Bed Safety Consulting, Inc.

March 20, 2006

Subject: Docket No. 2004D-0343

I am writing to express my concern as to the scope of the **Hospital Bed System Dimensional and Assessment Guidance to Reduce Entrapment** issued March 10, 2006. As it now stands, the Dimensional Guidance is organized around and pictorially displayed only for hospital beds with split side rails. The detailed attention given to split side rail bed systems leaves the impression that the dimensions presented for split side rail bed systems are freely transferable to any other type of hospital bed /side rail system. Unfortunately, for hospital beds with full length side rails attached to the bed deck with cross bars, see Figure 2, this impression is not correct.

FIGURE 1

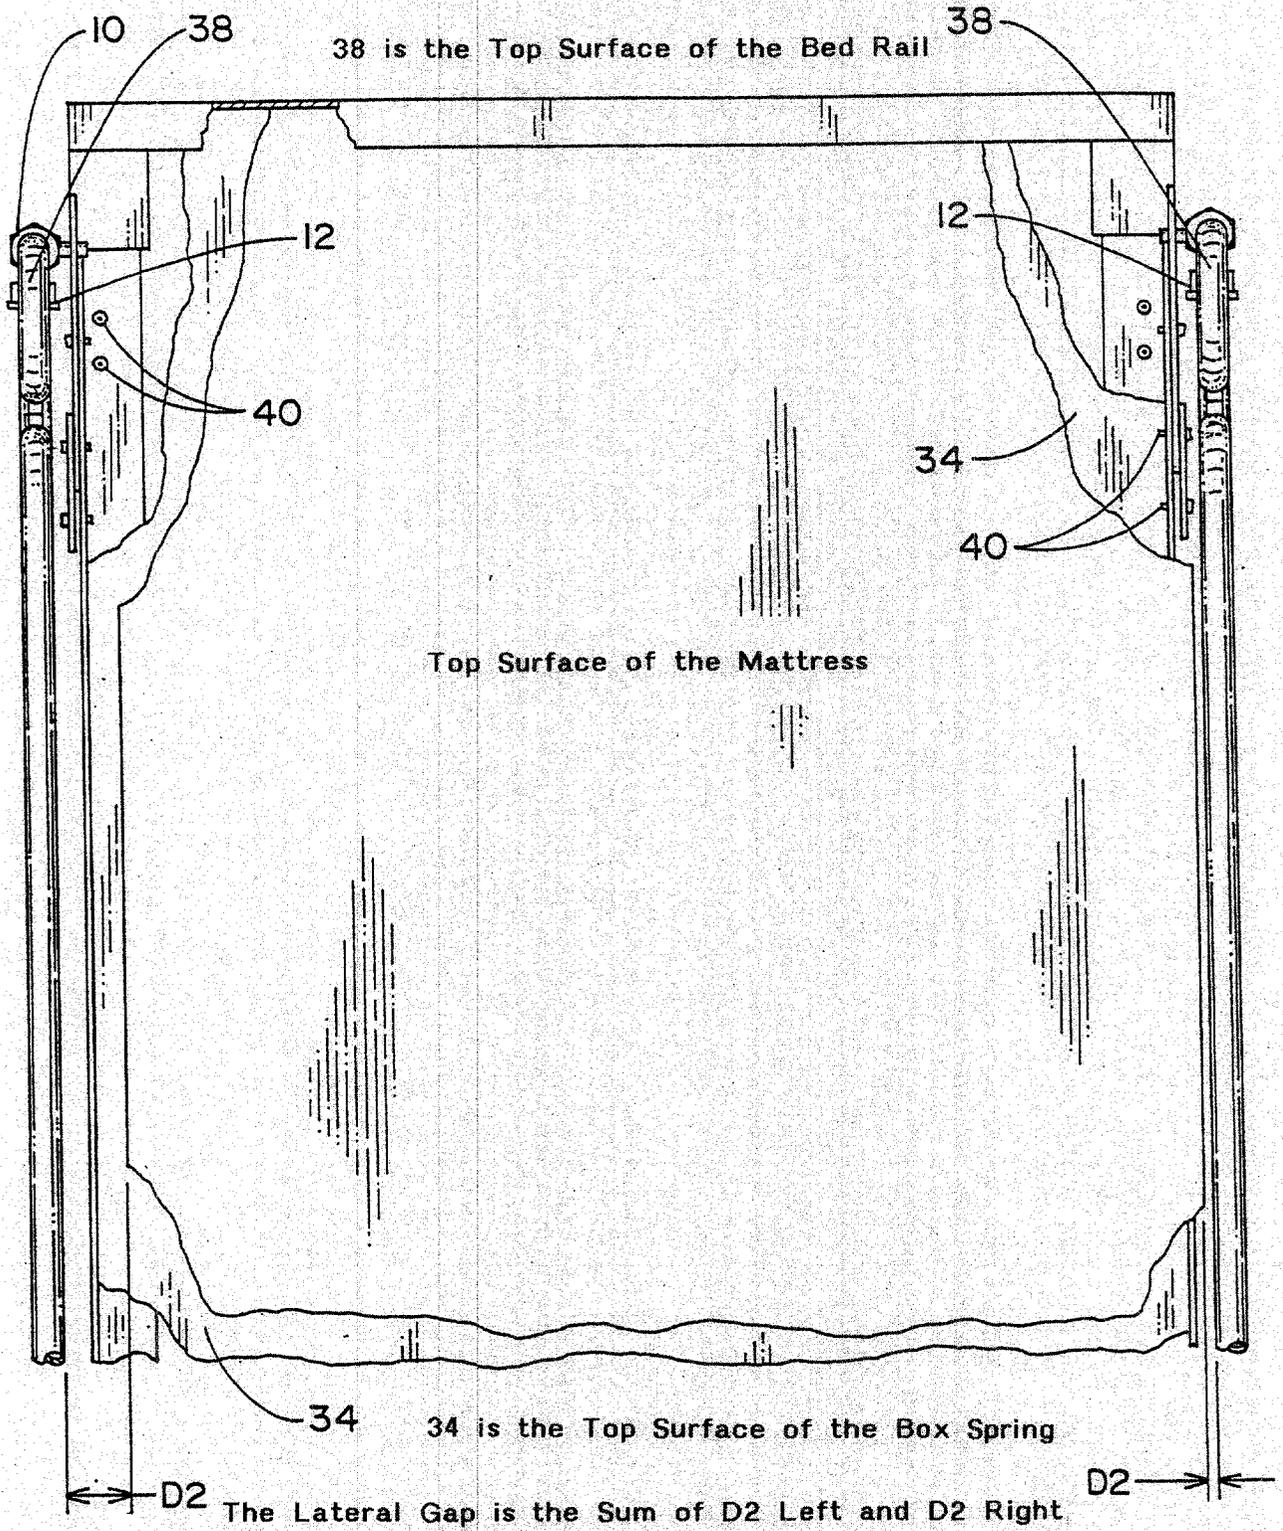
"Regrettably, only split side rails have been used to exemplify entrapment possibilities. Split side rails fail to demonstrate the full entrapment potential within Zone 3 that is present when full-length side rails are used, see Figure 1. Accordingly, the belief that the head blocks the entry of the neck into this gap is not true. With full length side rails, the legs slide between the side rail and the mattress and the weight of the legs pulls the trunk through the Zone 3 gap until either the chest or the head becomes entrapped."

It is my recommendation that a warning be immediately issued not to apply these split side rail dimensions to full length side rails with cross bars and that the appropriate standards, i.e. Checkpoints 2, 10, and 20, listed in the Bed Safety Checklist, see Attachment 1, be adopted for Zones 2 and 3 in beds with full length side rails attached to the bed deck with cross bars.

FIGURE 2

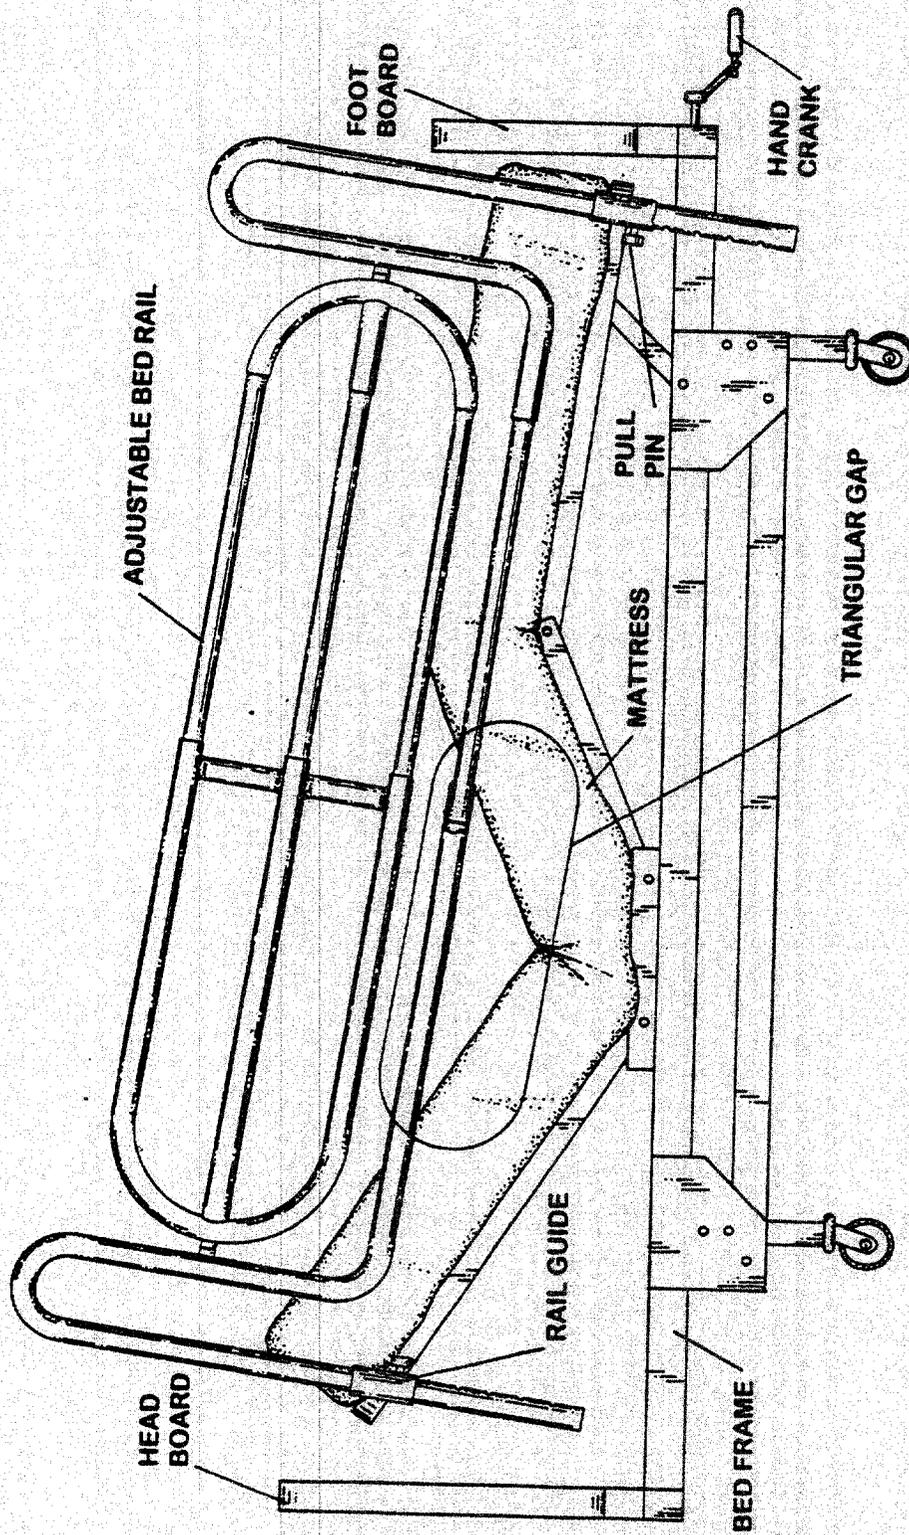
bed frame not the bed deck. When cross bars are used to attach the side rails to the bed deck, these telescoping side rails articulate with the head of the bed and the effect of this articulation on the under bar space in Zone 2, see Figure #2, is significantly more than that created by the bend in the mattress alone. Legs first entrapments have taken place in twin beds with full length side rails much less in an articulated hospital beds with a full length side rails in which the space in Zone 2 merges with the space in Zone 3 once the head of the bed is raised.

FIGURE 3

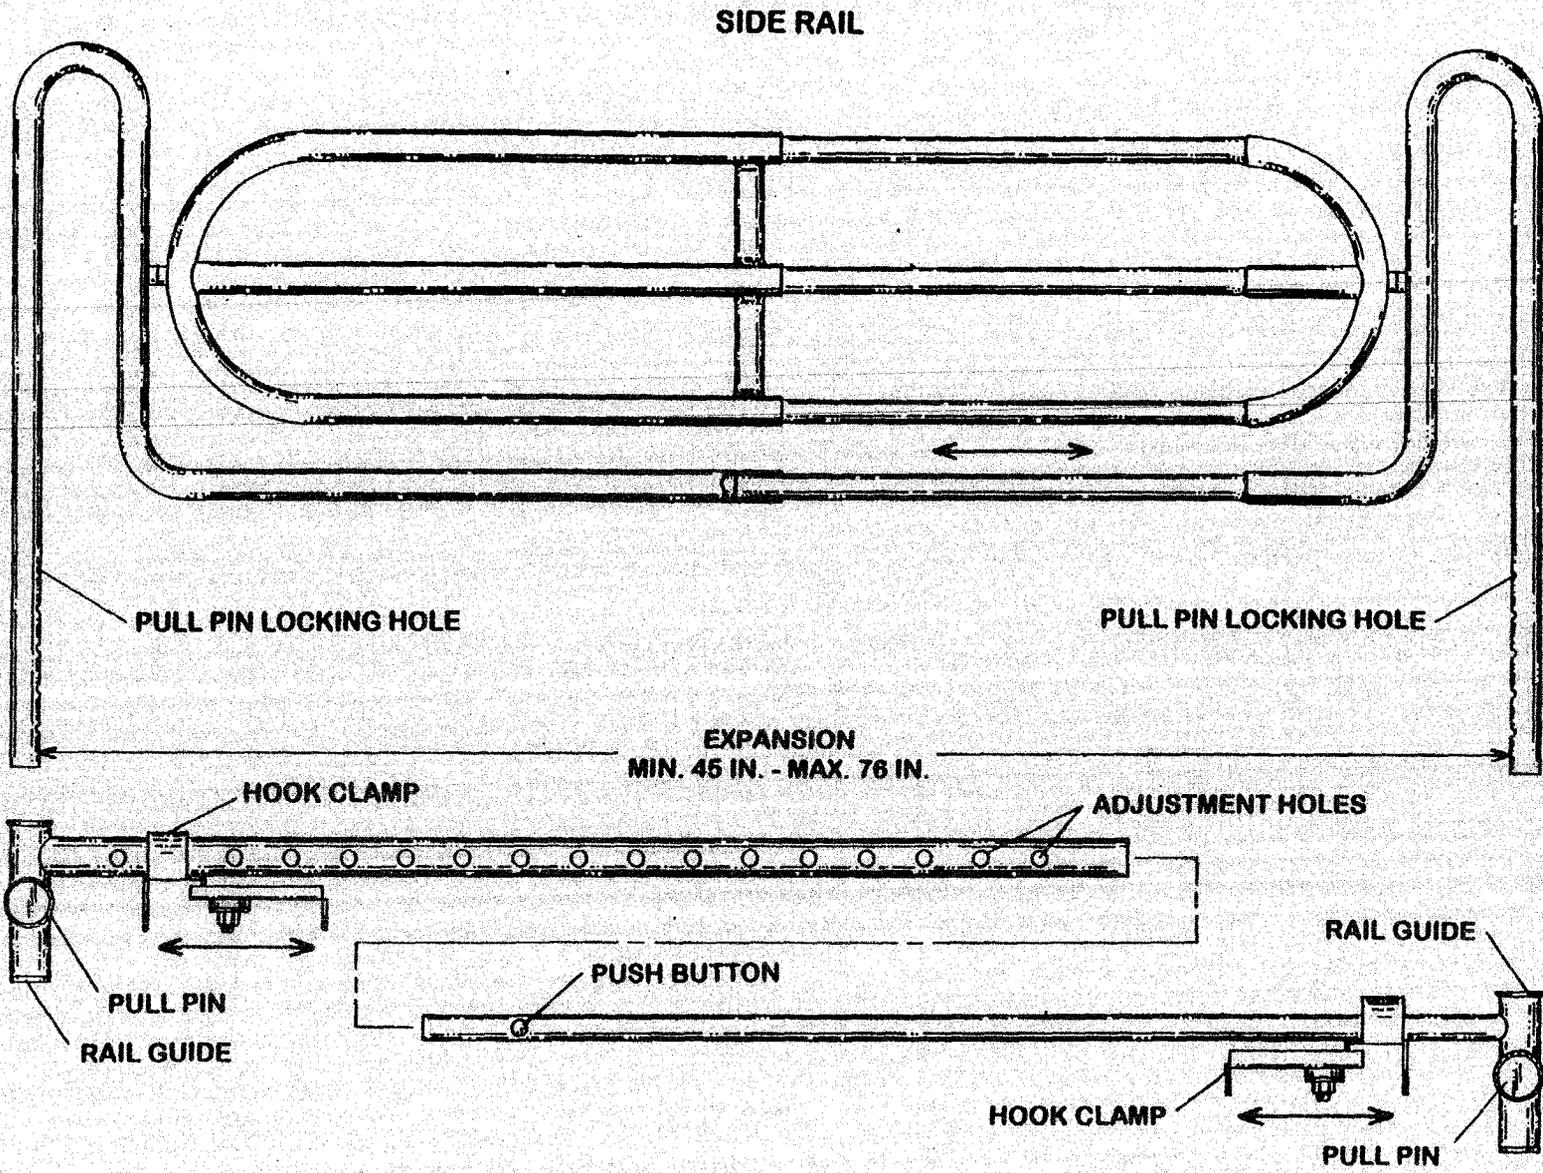
The second difference between split side rail bed systems and full length bed rail systems is that the cross bars can be expanded, thereby increasing the size of the gap in Zone 3, **without tools**. Figure 3 shows the placement of the rail guides relative to the bed deck is established by fitting a push button in one half of the cross bar into one of many adjustment holes on the other half of the cross bar. The ease and opportunity presented with push button adjustable cross bars to create the space needed for an entrapment has proven to be fatal.
